Calculation/Analysis Change Notice

| 3. Document Identifier: 050-PSA-WH00-00100-000-00A | ENG. 20080312.0009 | 4. Rev.: 00A | 5. CACN: 001 <i>of 3/11/08</i> |

6. Title:
Wet Handling Facility Event Sequence Development Analysis

Figure F-11. WHF-ESD-11 Event Sequences Associated with Movement of an Aging Overpack/DPC or Aging Overpack/TAD on Site Transporter, through Site Transporter Vestibule, Aging Overpack Access Platform, and Loading Room (Receipt or Export)

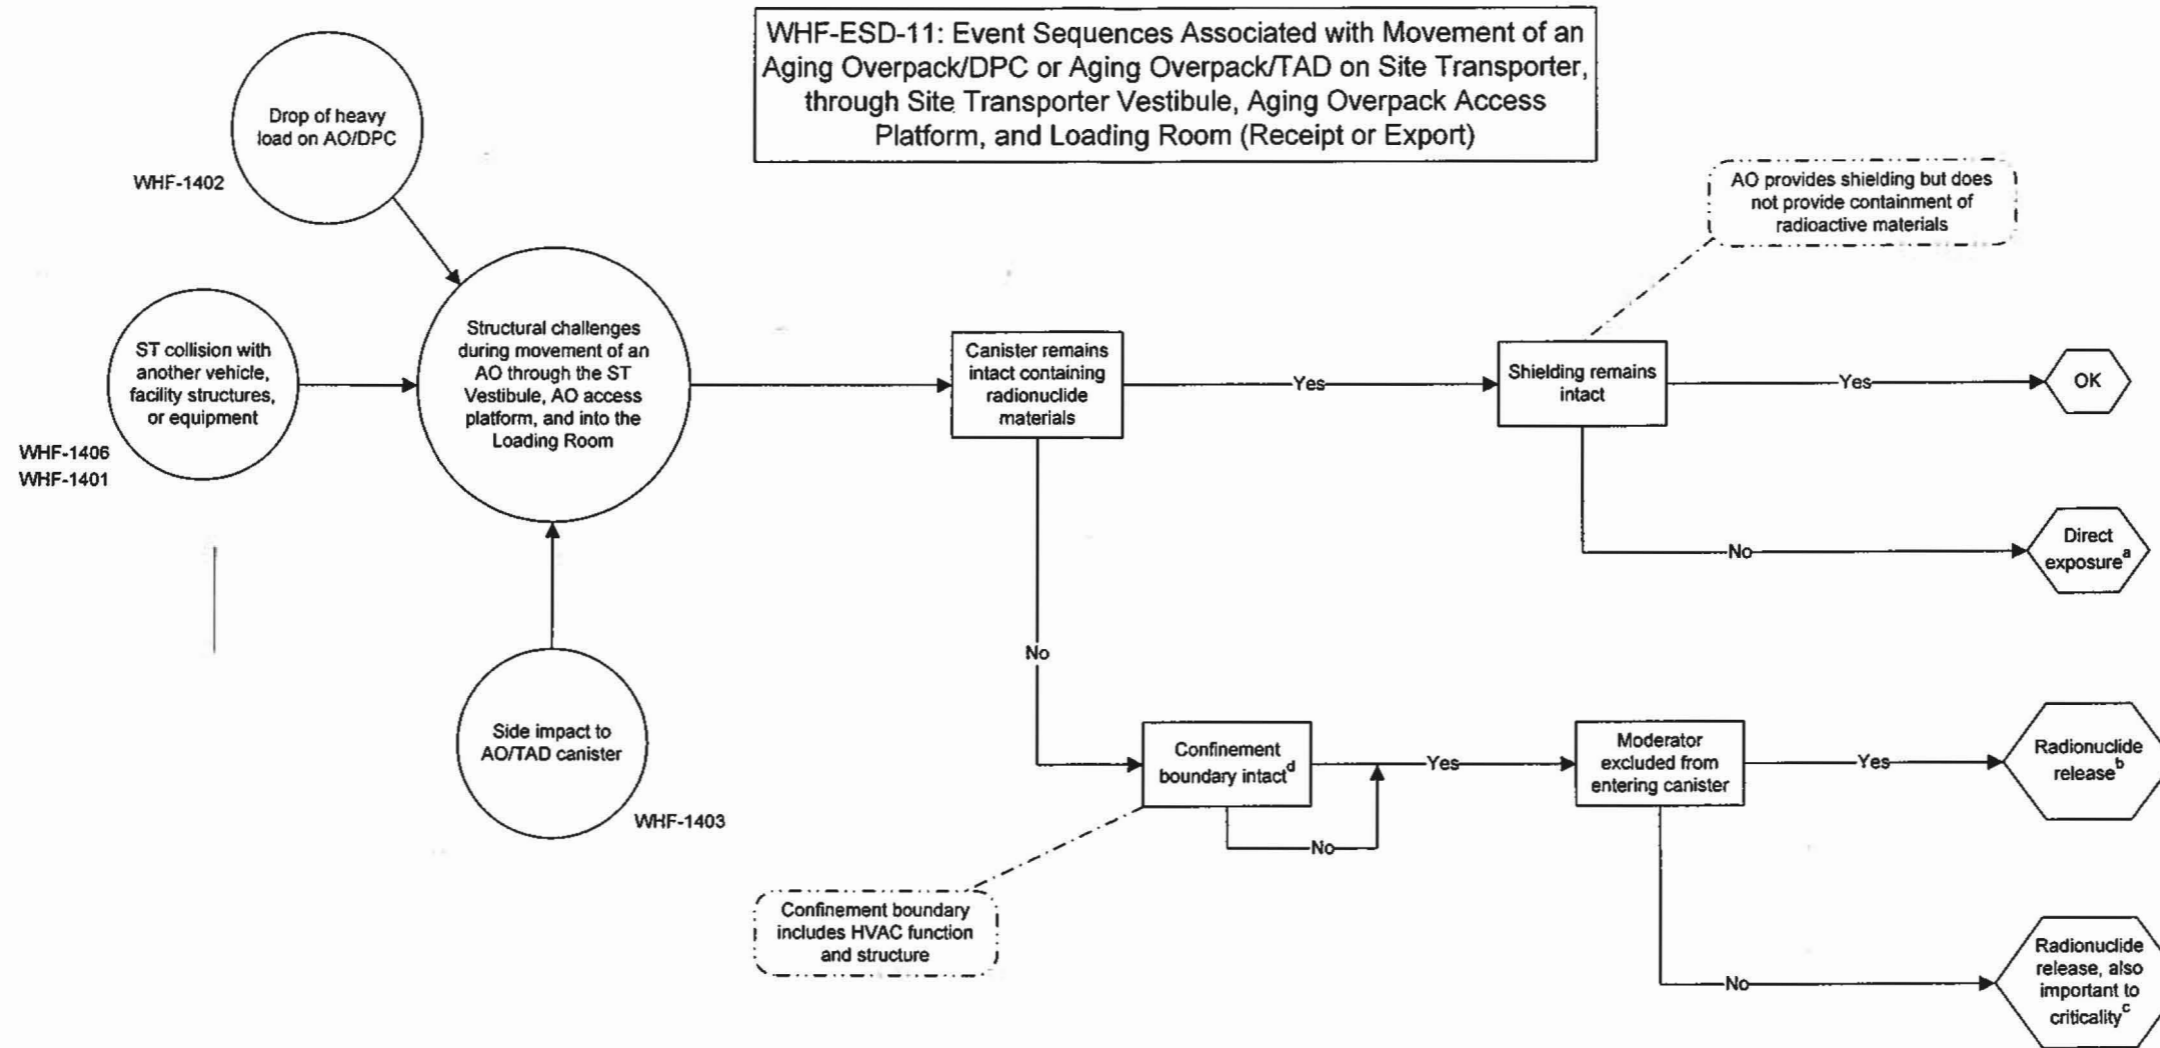
This CACN001 corrects the list of internal initiating events presented in Table 10 by deleting initiating events associated with the jib crane impacting the AO/ST at the AO access platform. It also updates Section 6.2.12.2, which describes the affected initiating events, and updates the affected ESD (Fig. F-11) and event trees (Figures G-18 and G-19).

- 1/ Page 98 – delete row with entry “WHF-1403” and “WHF-1407” from Table 10
- 2./ Page 121, Section 6.2.12.2 – delete entry no. 3
- 3/ Page F-12, Figure F-11 – Delete third “small bubble” and entries
- 4/ Page G-22, Figure G-18 – Change label of the 4th branch from “AO/DPC tip over” to “AO/DPC tip over (deleted)”
- 5/ Page G-23, Figure G-19 – Change label of the 4th branch from “AO/TAD tip over” to “AO/TAD tip over (deleted)”
